# PRODUCT/PROCESS CHANGE NOTICE (PCN)

PCN #: A1910-01 DATE: 29-Oct-	2019 MEANS OF DISTINGUISHING CHANGED DEVICES:			
Product Affected: FCCSP-53, FCCSP-253 (Refer to attachment II for affected part	<ul> <li>#)</li> <li>Product Mark</li> <li>Back Mark Traceable through lot#</li> <li>Date Code</li> <li>Other</li> </ul>			
Date Effective: 29-Jan-2020				
Contact: PCN DESK	Attachment: Yes No			
E-mail: <u>idt-pcn@lm.renesas.com</u>	Samples: N/A			
DESCRIPTION AND PURPOSE OF CHANGE:				
<ul> <li>Assembly Process</li> <li>Equipment</li> <li>Material</li> <li>Attachment I detail</li> </ul>				
<b>RELIABILITY/QUALIFICATION SUMMARY:</b> N/A				
CUSTOMER ACKNOWLEDGMENT OF RECEIPT: IDT records indicate that you require written notification of this change. Please use the acknowledgement below or E-Mail to grant approval or request additional information. If IDT does not receive acknowledgement within 30 days of this notice it will be assumed that this change is acceptable. IDT reserves the right to ship either version manufactured after the process change effective date until the inventory on the earlier version has been depleted.

### **ATTACHMENT I - PCN # : A1910-01**

Assembly process flow as detailed below.

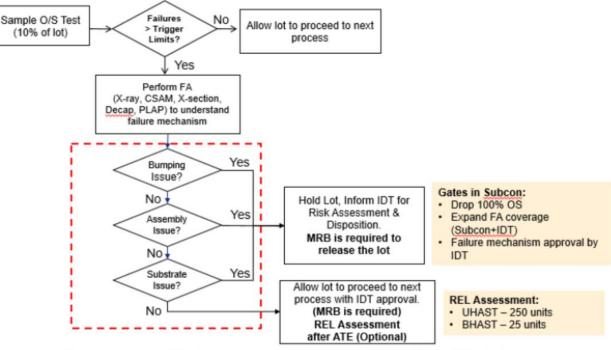
This notification is to advise our customers that Sample Open/Short test will be introduced at Assembly Process at Amkor Korea and Stats Chippac, Korea at the request of the customers.

Bumping Issue: Missing bumps, Open bumps, UBM Defects, RDL defects. Assembly Issue: Bump bridge, Missing bump, Delamination, Die Crack. Substrate Issue: Shorting Trace, Open Trace, Open Via.
